Product / Process Change Notification (PCN)

PCN #: PCN_FeAFB_20221128

Affected Series: WE-AFB; 74270033

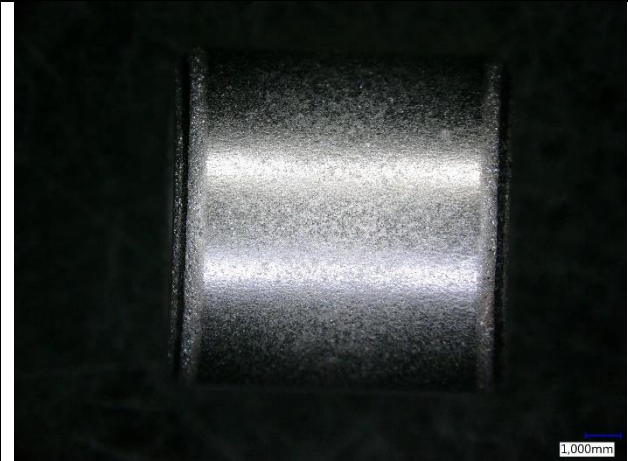
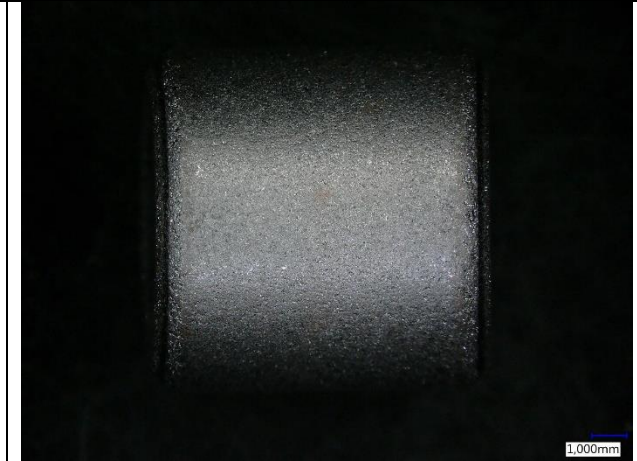
The grinding process of 74270033 will be changed from a manual to an automated tumble grinding process. This can lead to a minimal change in the surface texture.
